ADDENDUM NUMBER 2

Re: North Brunswick High School HVAC
South Brunswick High School HVAC
West Brunswick High School HVAC
Brunswick County Schools
Proj. Number: PC21P0006

MDI Proj. No.: 213763

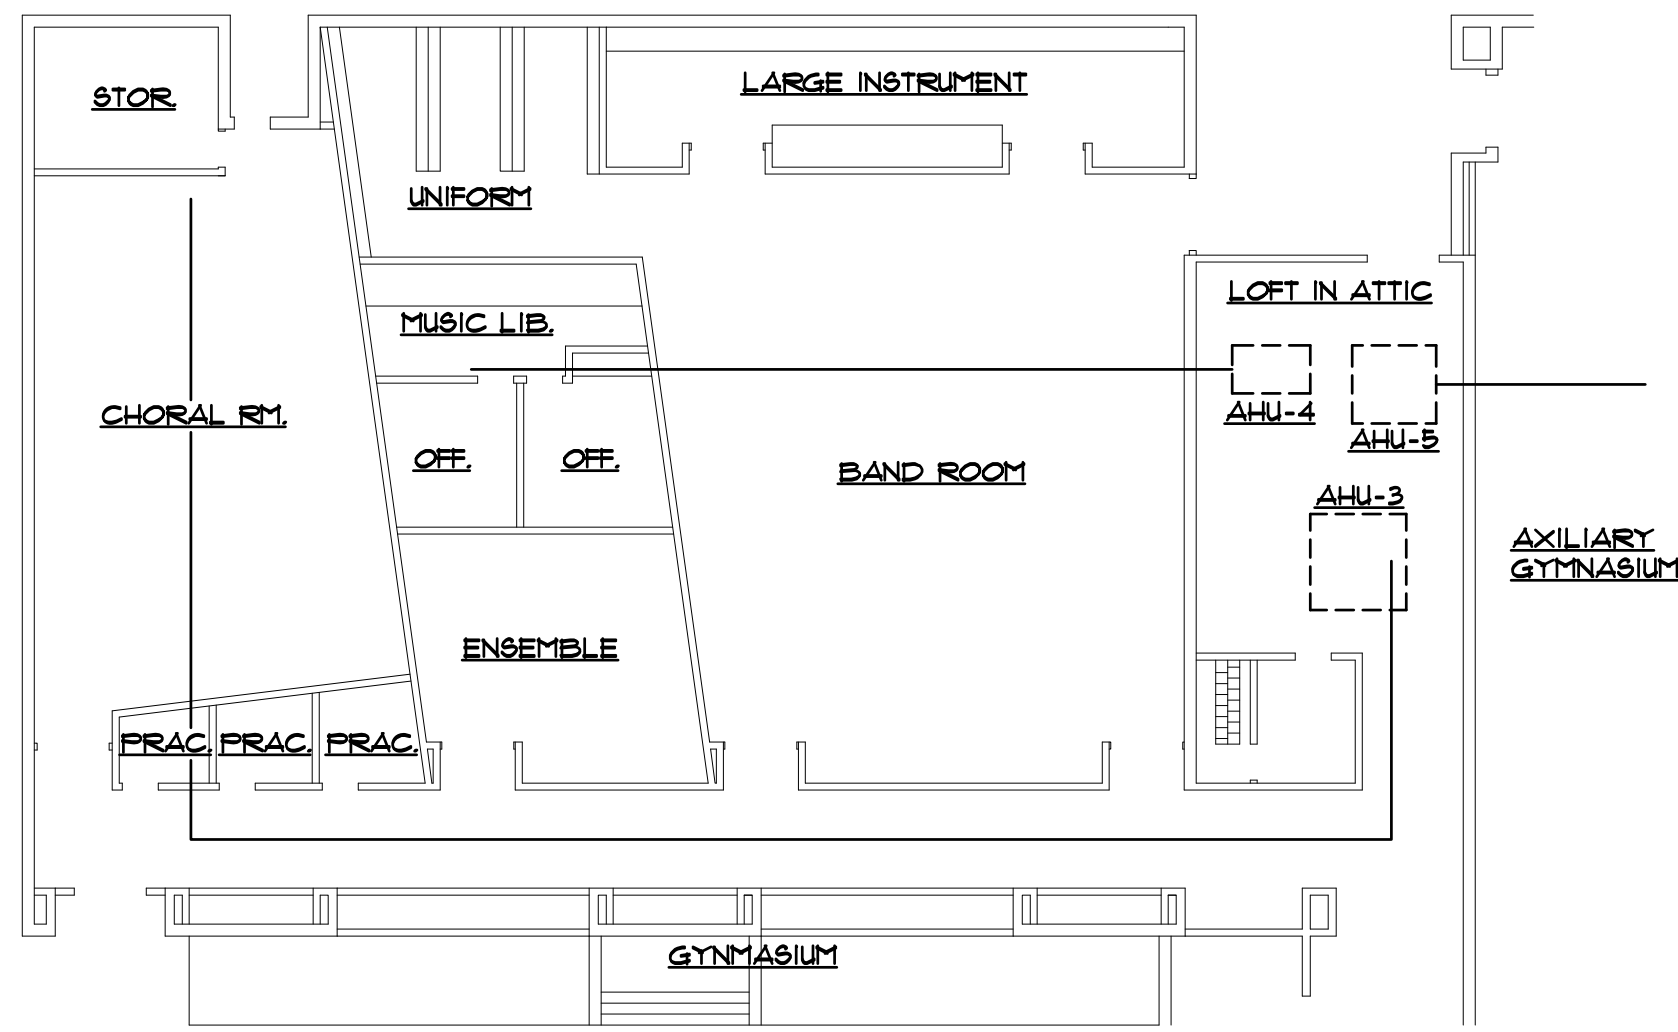
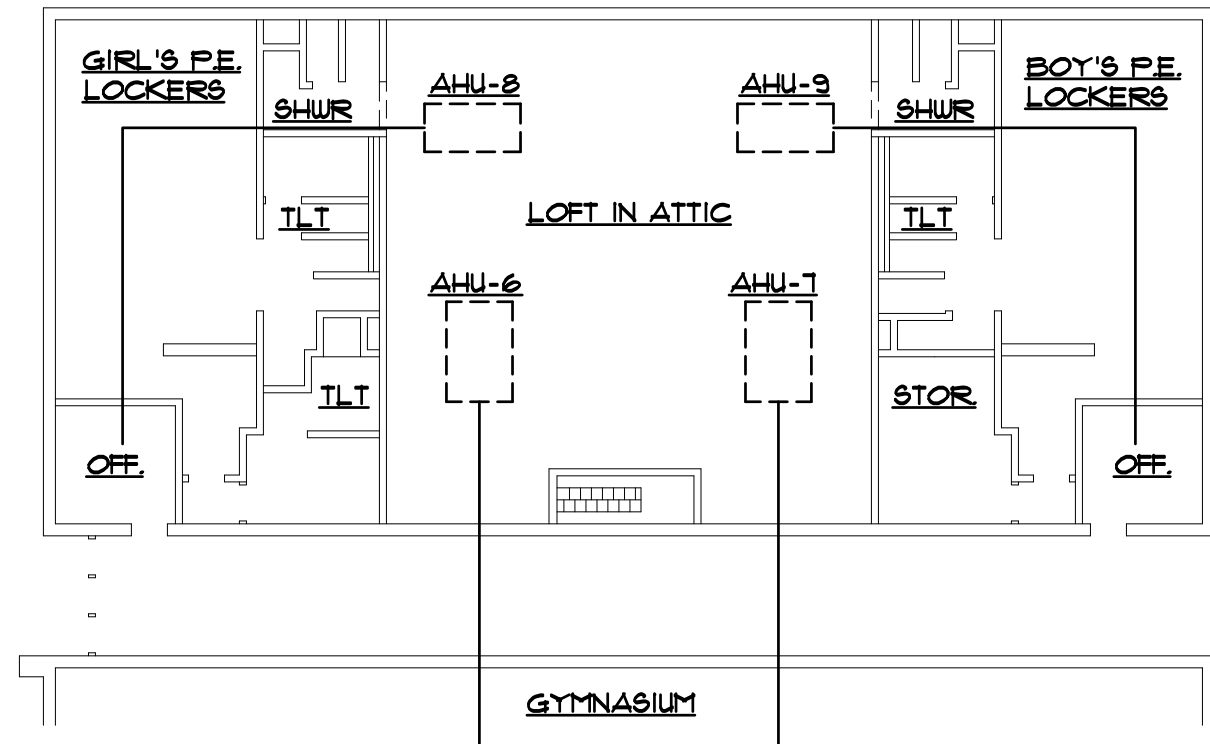
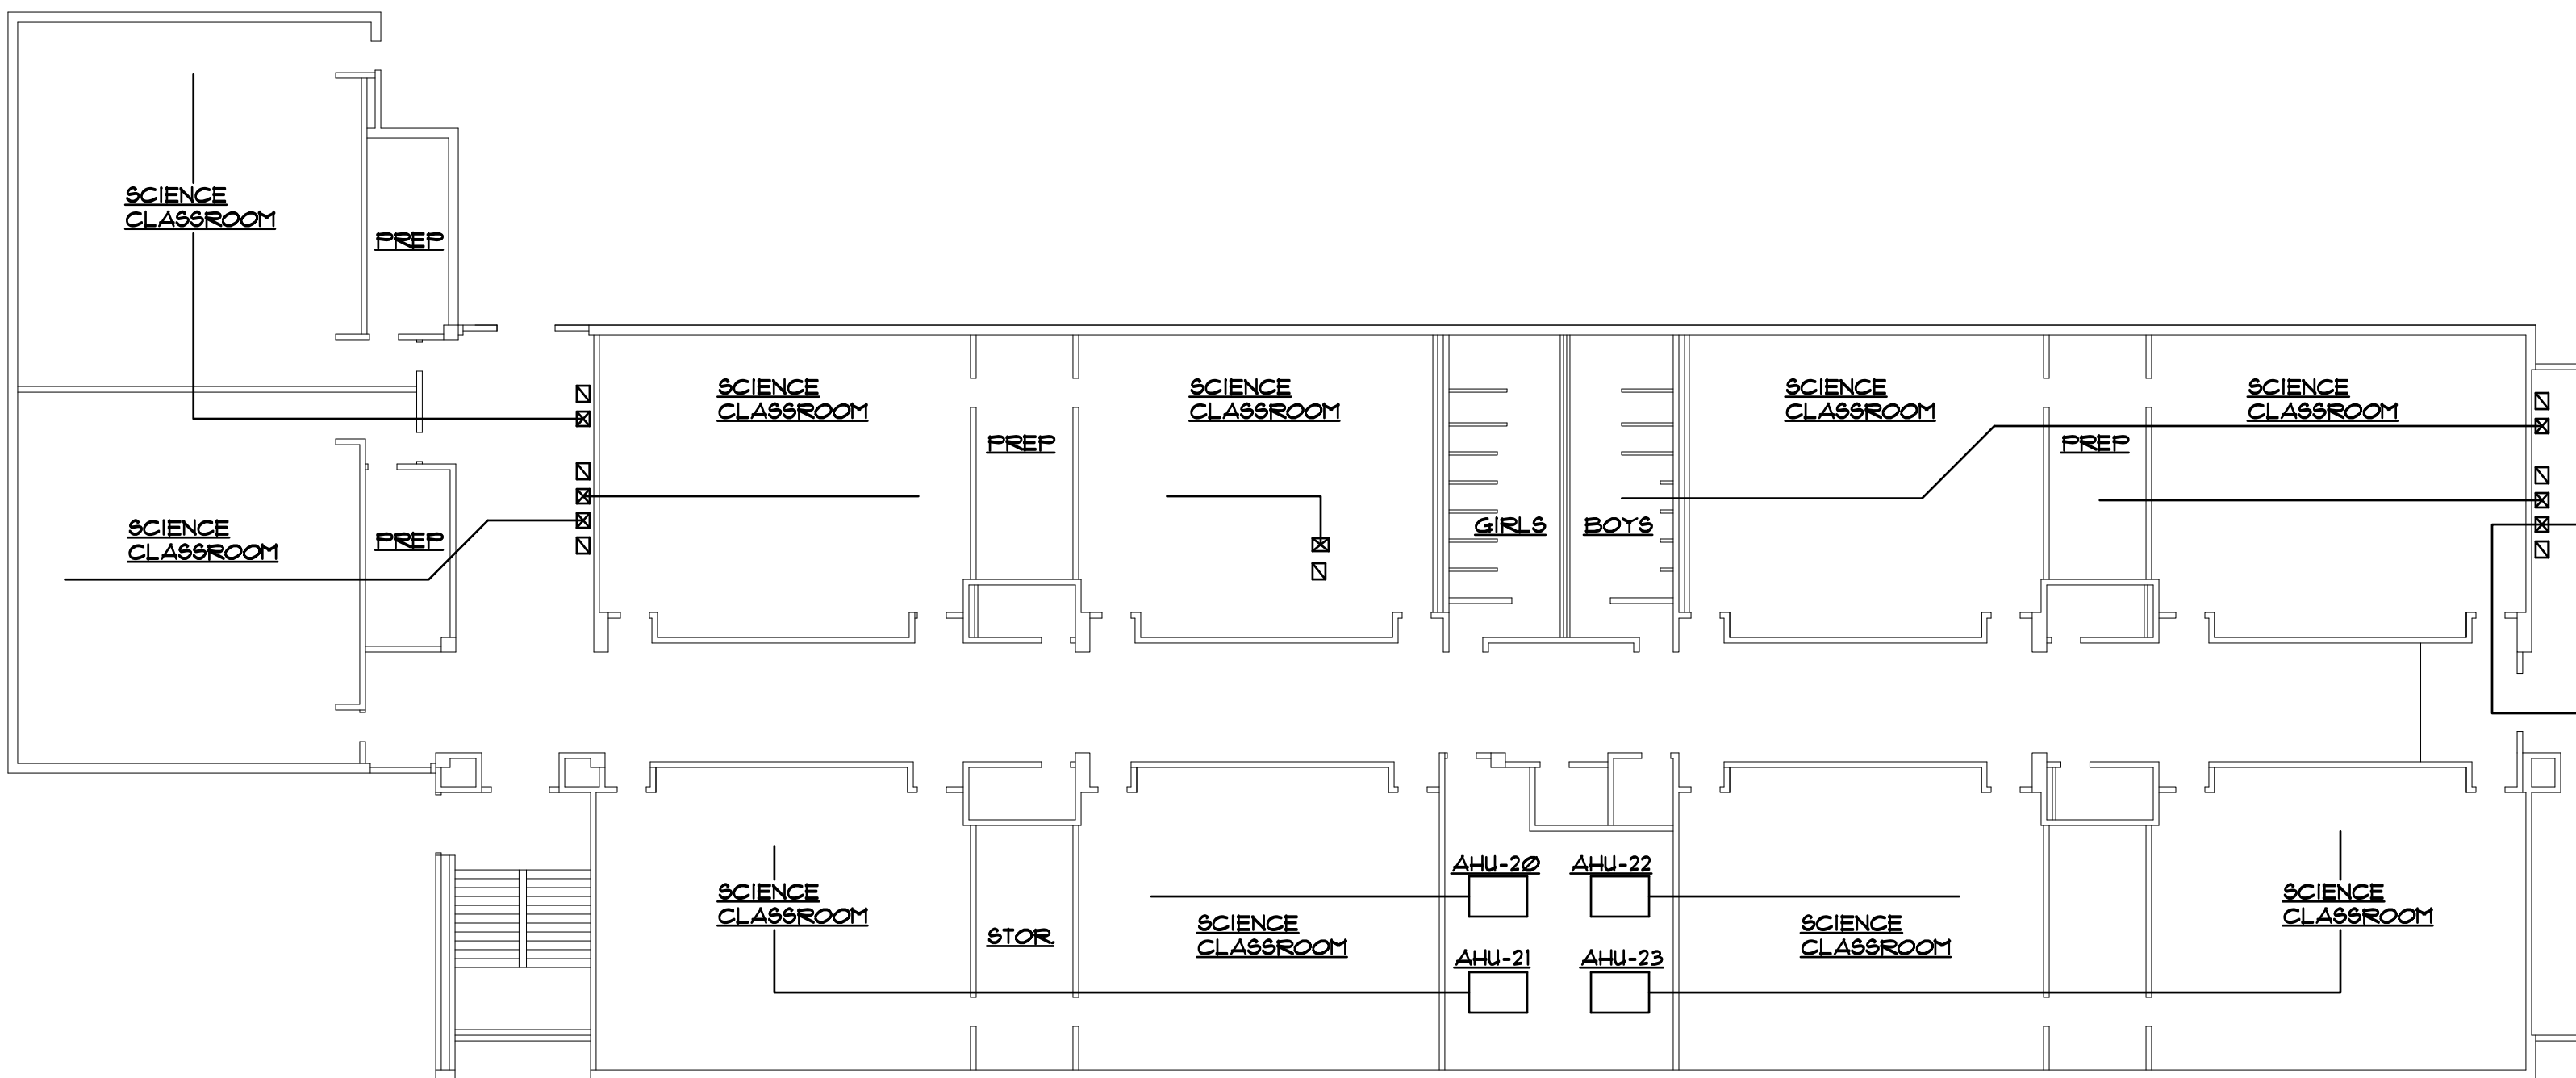
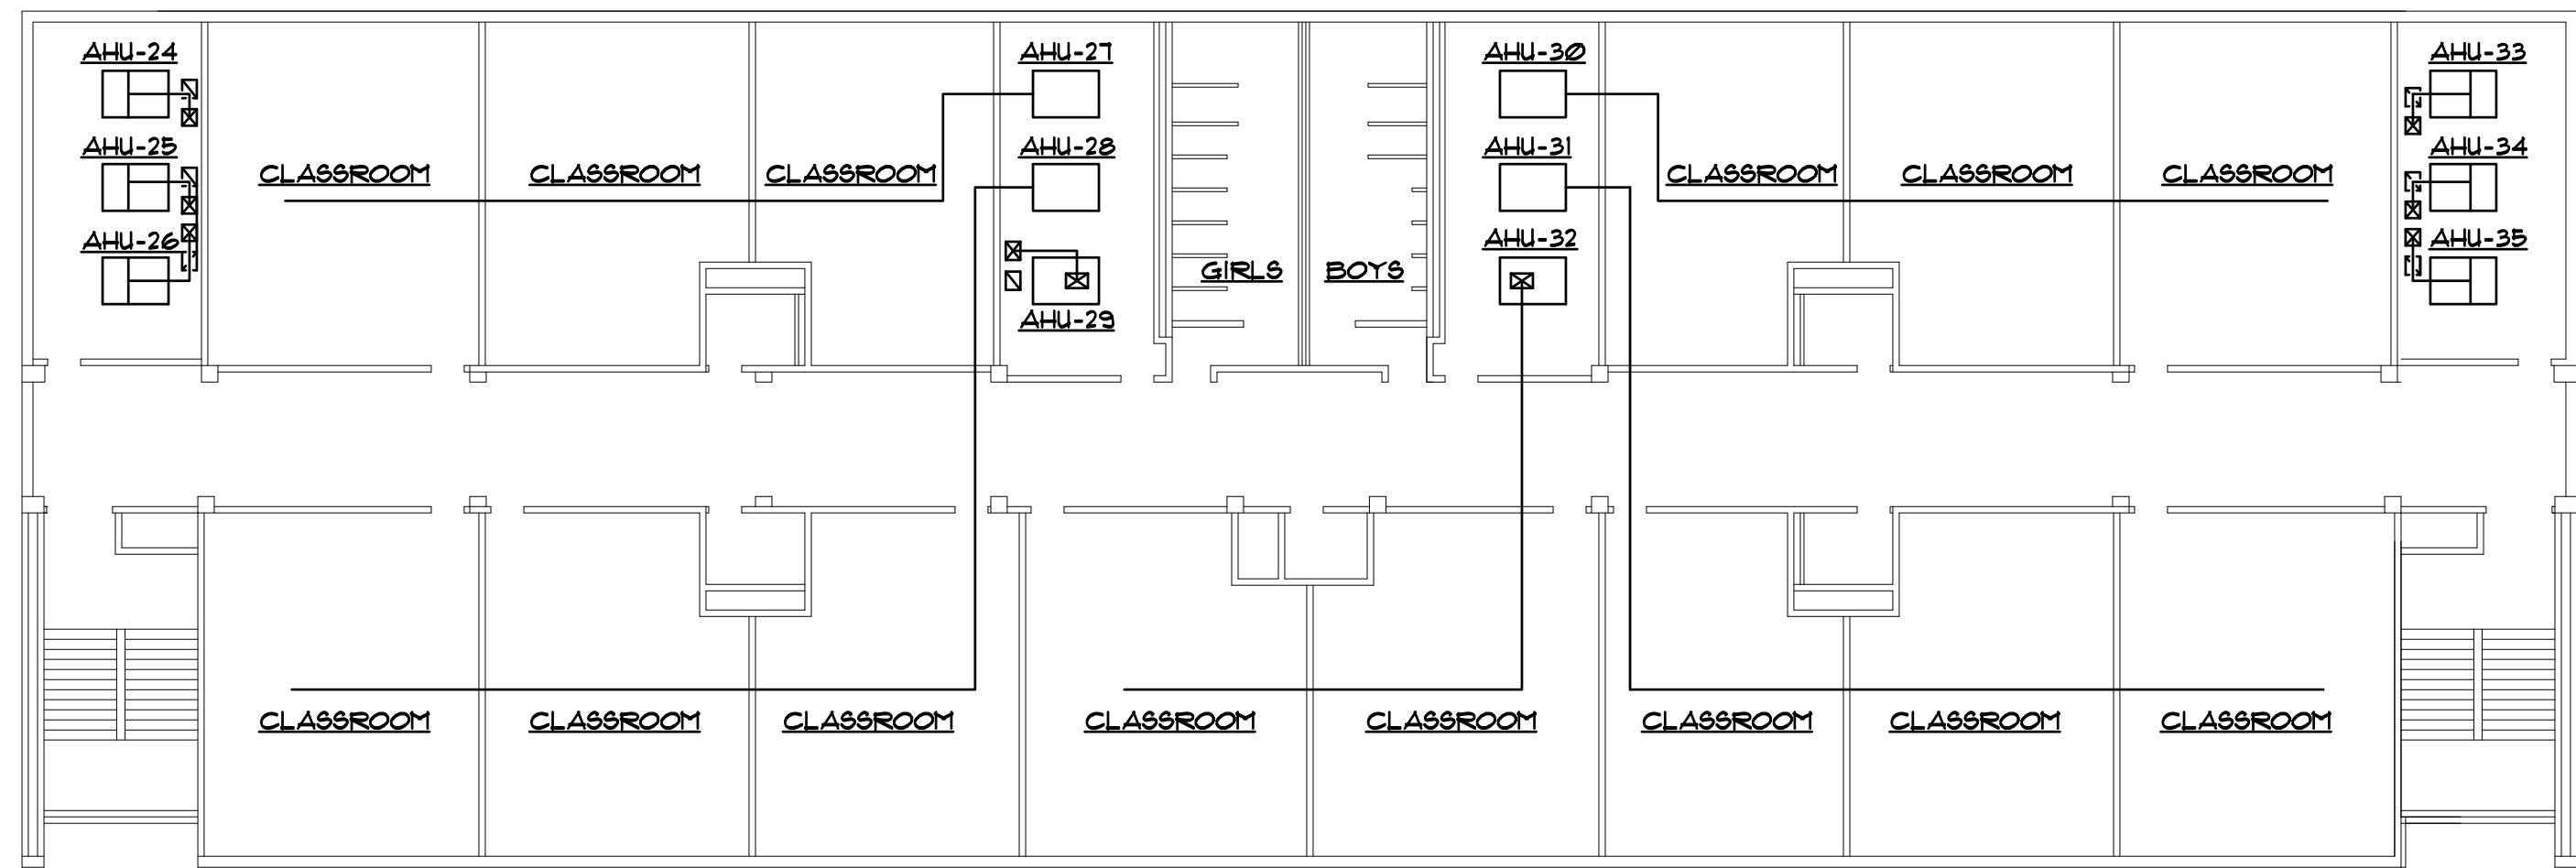
7. Refer to West Brunswick High School drawing M104A, areas "C", "D", "E", "G" and "I". Remove existing control valves complete, and replace with new control valves furnished by automatic temperature controls company as noted on the Control Valve Replacement Schedule on M001A.
